TECHNICAL MEMORANDUM

DATE: April 1, 2009

SUBJECT: Response to IDWR's March 2, 2009 Staff Memorandum
On M3 Eagle Hydrogeologic Studies

Figure 9. Comparison of Water Level Data Plot on IDWR Website with Analysis of Selected Data by McVay for Well 04N01E 11BBB1

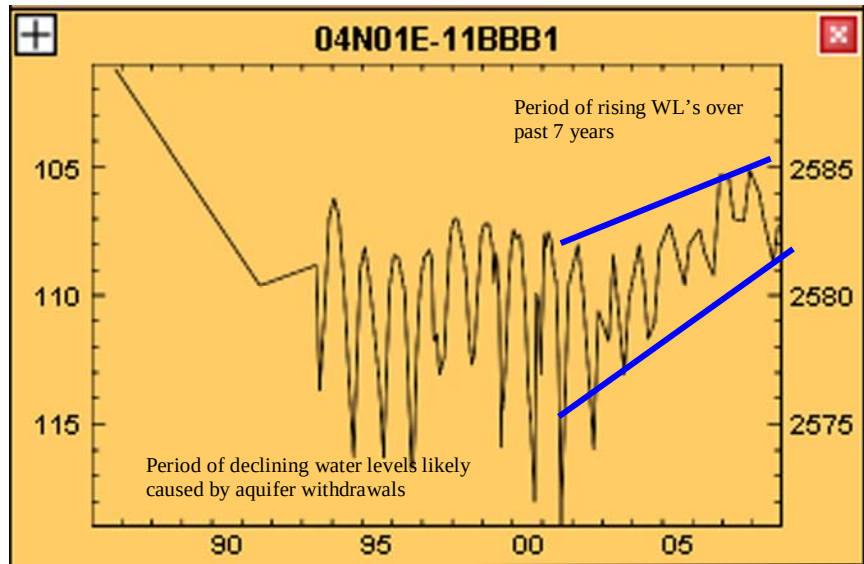
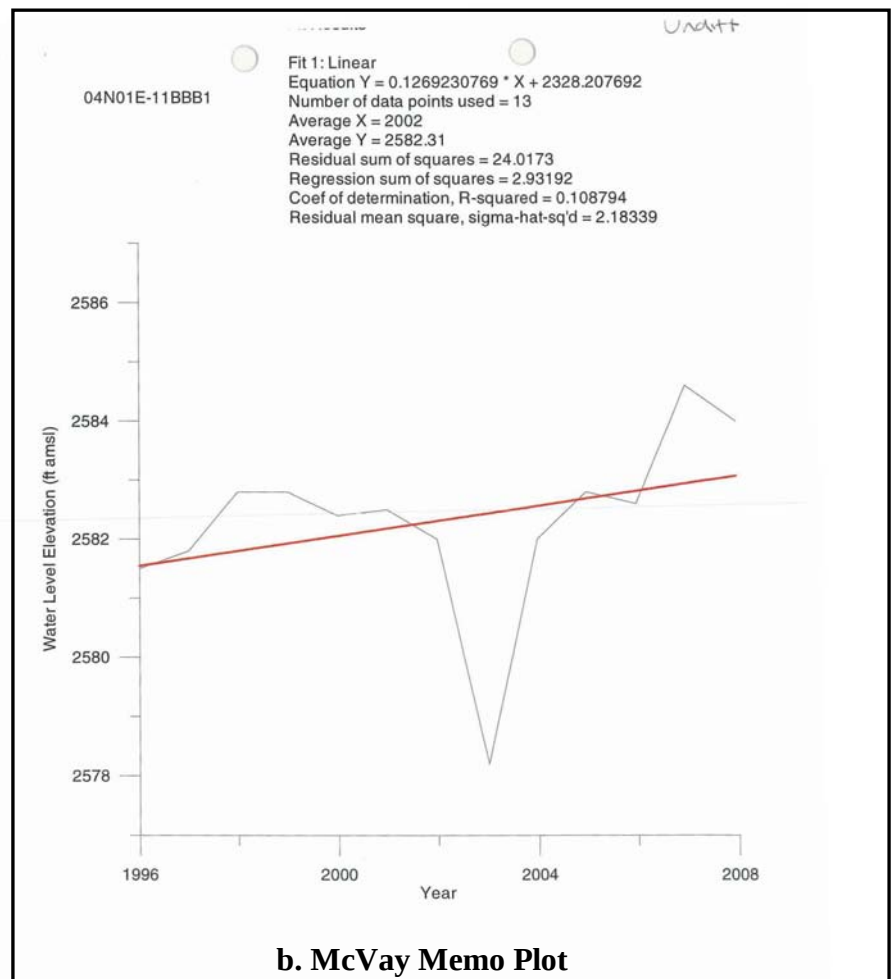
McVay's plot shows a steadily rising "non-irrigation season" water level. McVay's analysis of 13 data points **agrees with the apparent rise in water levels in this portion of the Terteling Springs Formation mudstone aquifer** as shown in the plot of all 111 data points.

Figure 10. Comparison of Water Level Data Plot on IDWR Website with Analysis of Selected Data by McVay for Well 04N02W 07AAC1

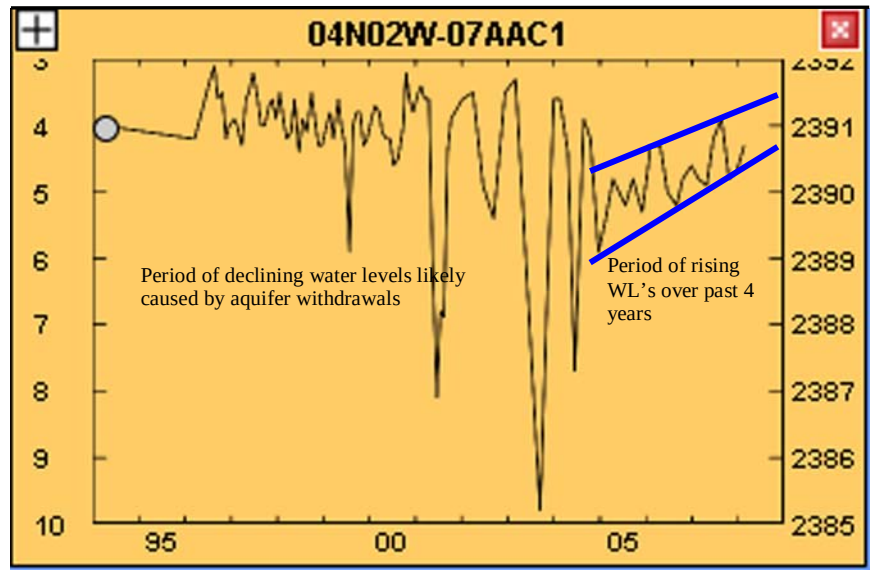
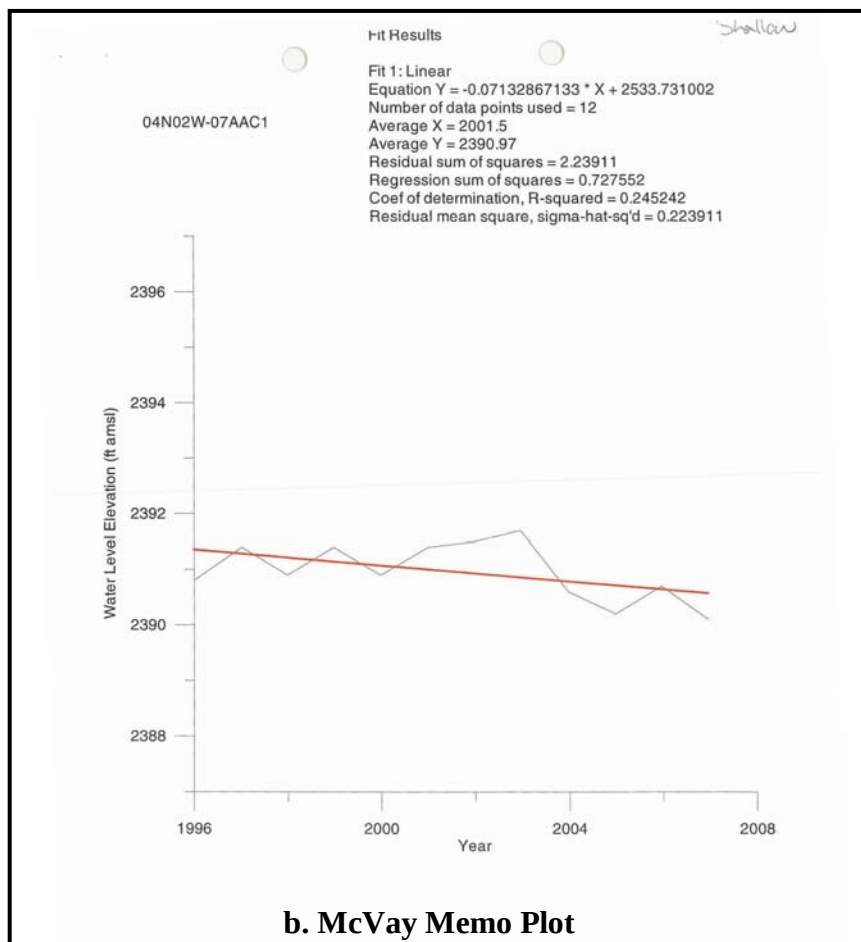
McVay's plot purports to show a steadily declining "non-irrigation season" water level. By ignoring the visual trend apparent in the complete data plot, McVay's analysis combines data from a period of water level decline with a period of water level rises and gives a **false indication of true conditions in the Boise River gravel aquifer.**

Figure 11. Comparison of Water Level Data Plot on IDWR Website with Analysis of Selected Data by McVay for Well 05N03W 12CCA1

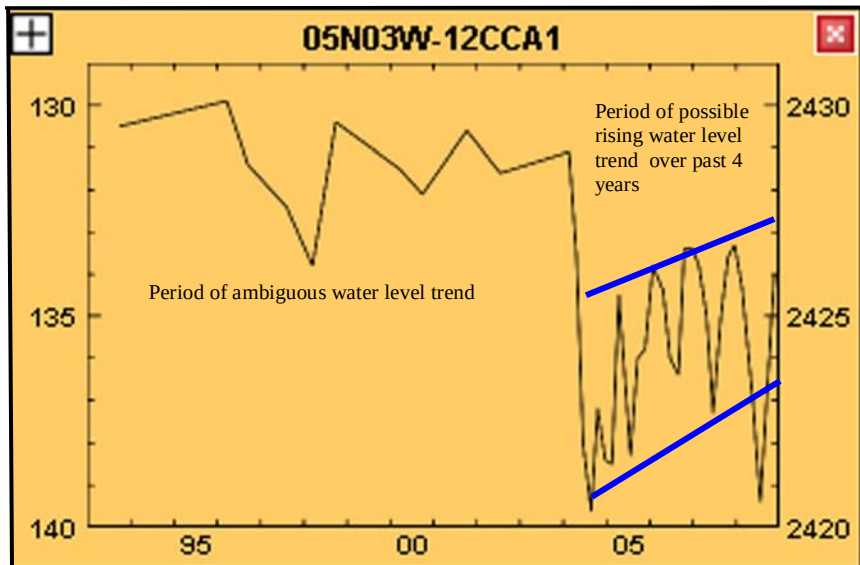
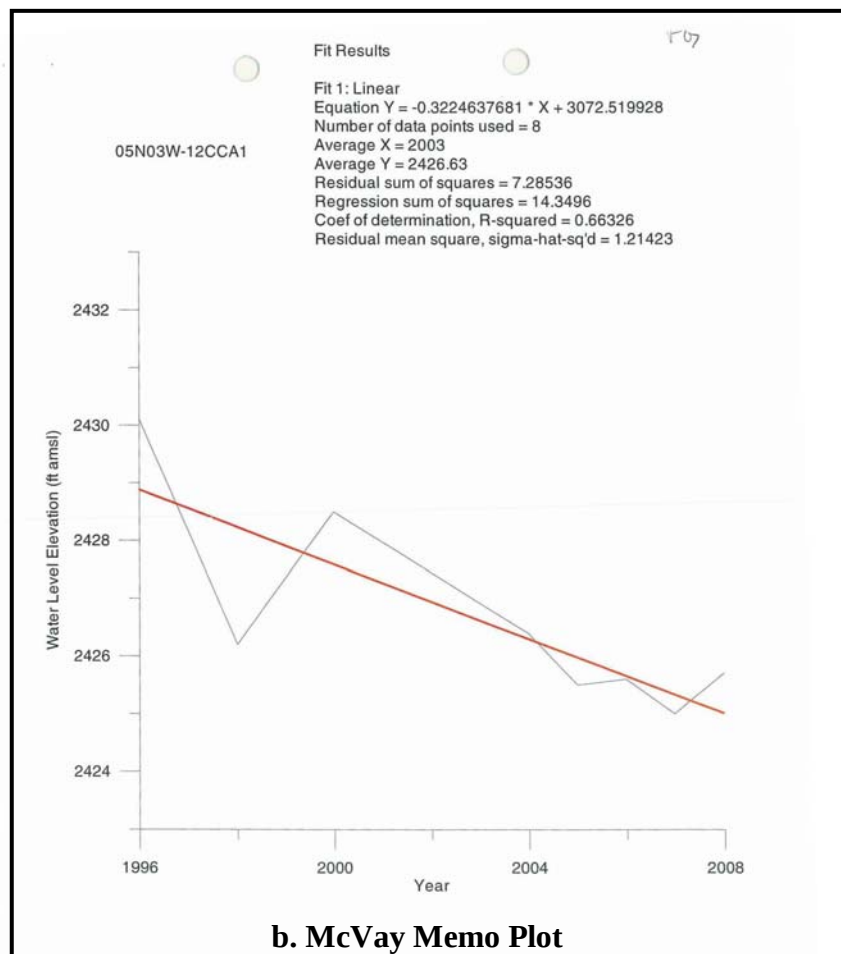
McVay's plot purports to show a steadily declining "non-irrigation season" water level. By ignoring the visual trend apparent in the complete data plot, McVay's analysis combines data from a period of water level decline with a period of water level rises and gives a **false indication of true conditions in the Pierce Gulch Sand Aquifer.**
